STAKEHOLDER ADVISORY FORUM (SAF)

Central Carrizo-Wilcox Aquifer GAM Model

August 28, 2002

Forum Meeting No. 6
Thursday, August 28, 2002, 1:30 p.m.
Hearne Community Center

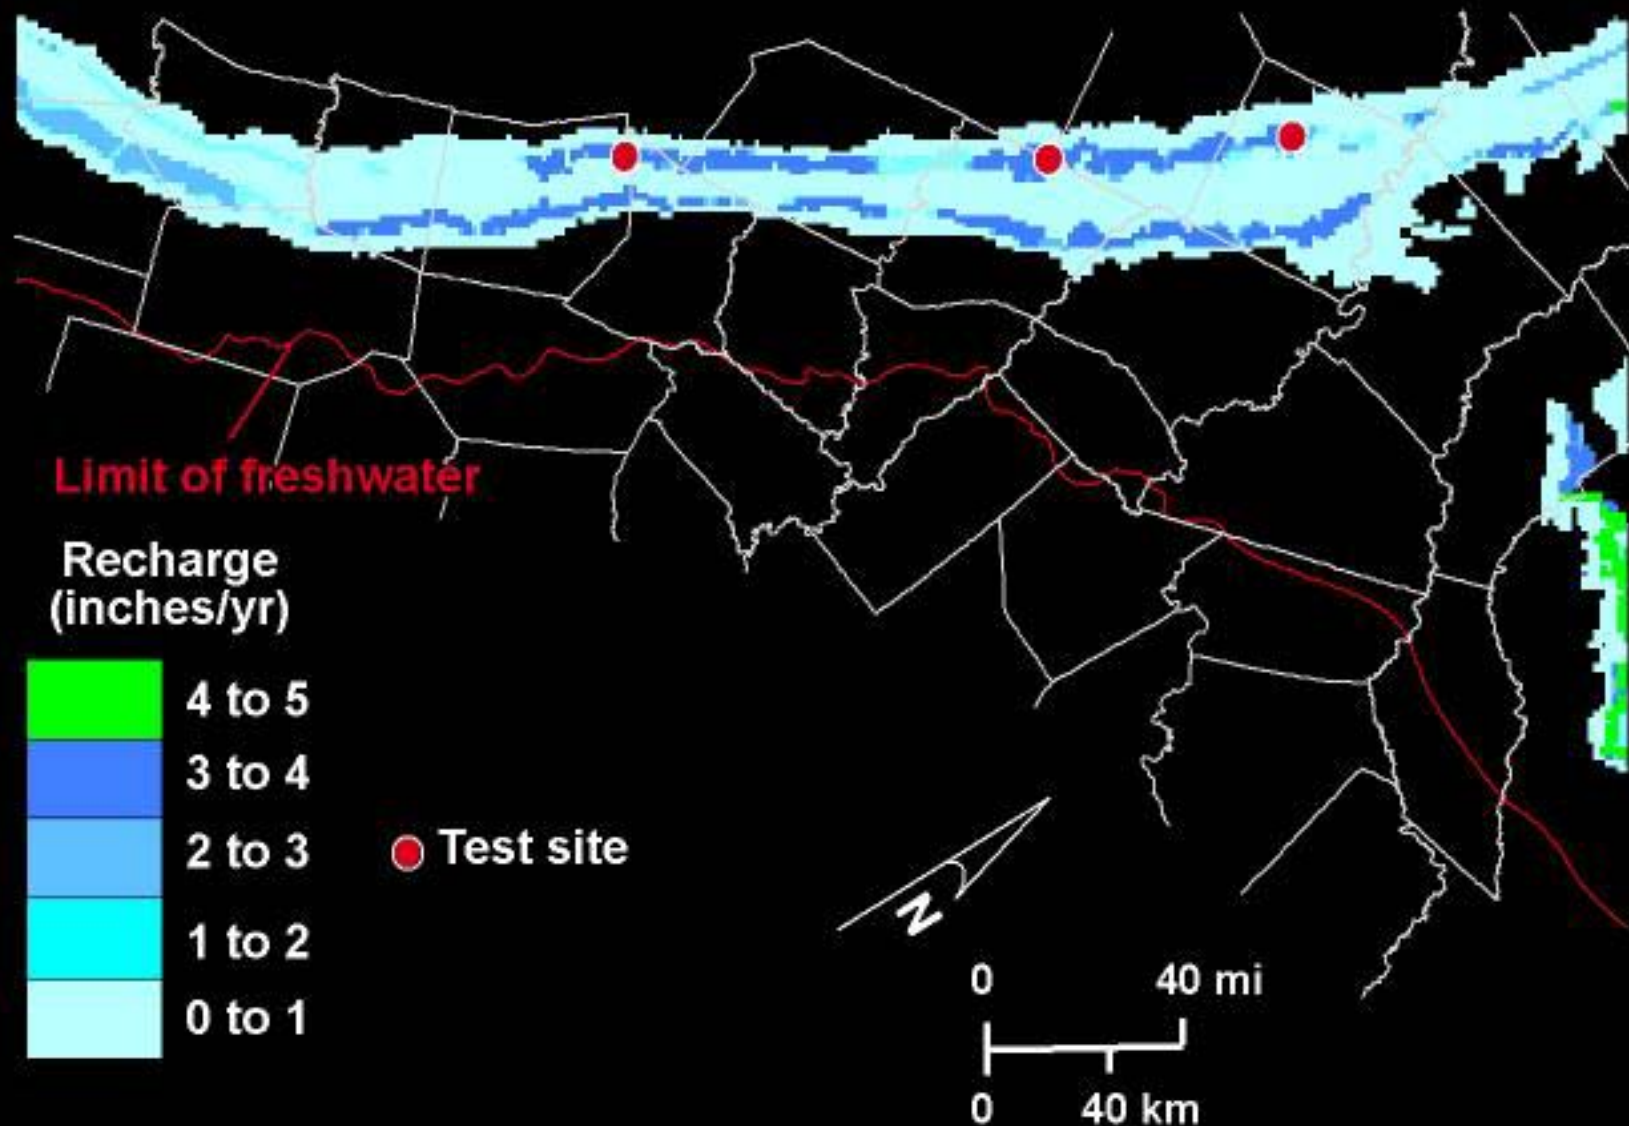
Q: There is a discrepancy between recharge units shown on the histogram and map.

A: The version of figure 20 included in SAF6_CW-c.pdf on the website has been corrected since the SAF forum. The histogram (figure 19) included the right numbers but the map (figure 20) shown at the meeting was an incorrect version. The correct version included in SAF6_CW-c.pdf shows more recharge in the Carrizo aquifer across the Sabine Uplift area.

Comparison of Simulated and Estimated Potentiometric Surface Simsboro

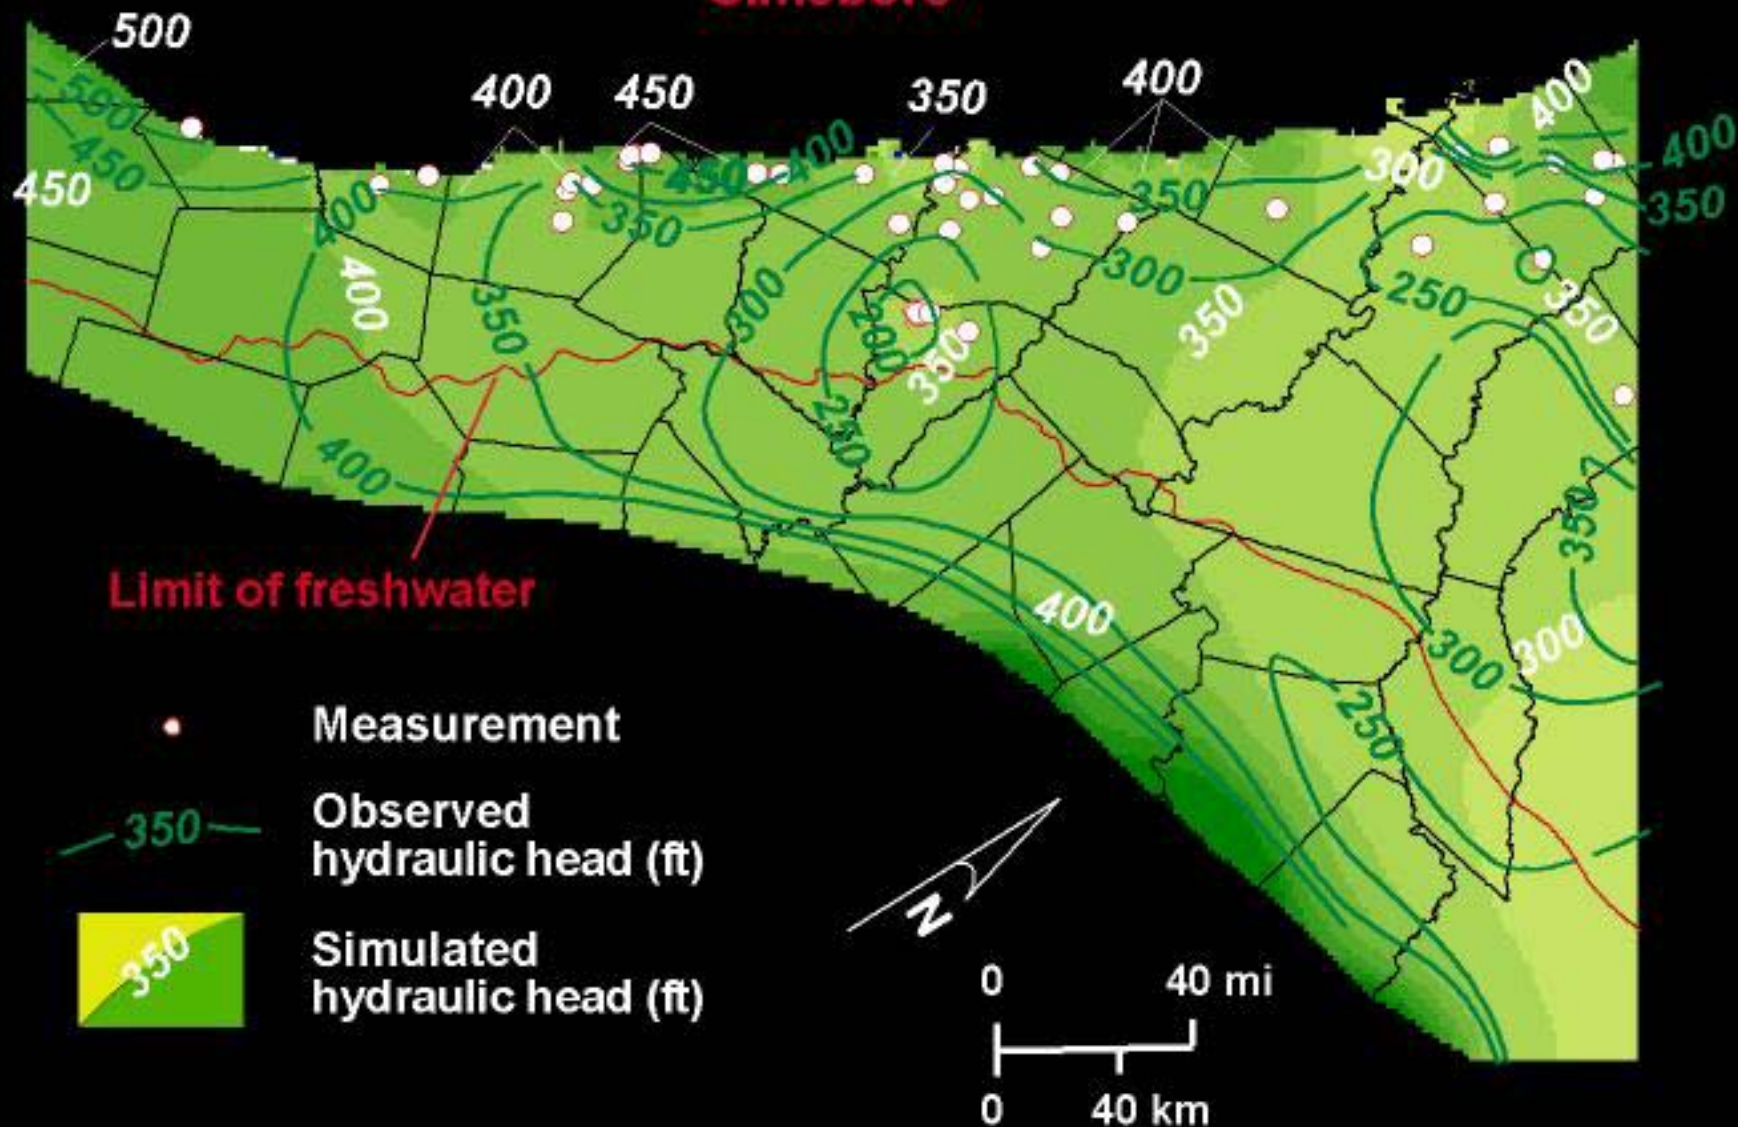
Q: What is the status of calibration shown here; is it good enough?

A: The illustrations are labeled (for example, figure 28) as interim calibration. Calibration phase of work at this point is about 95 percent complete. Additional work is planned to meet the calibration goal.
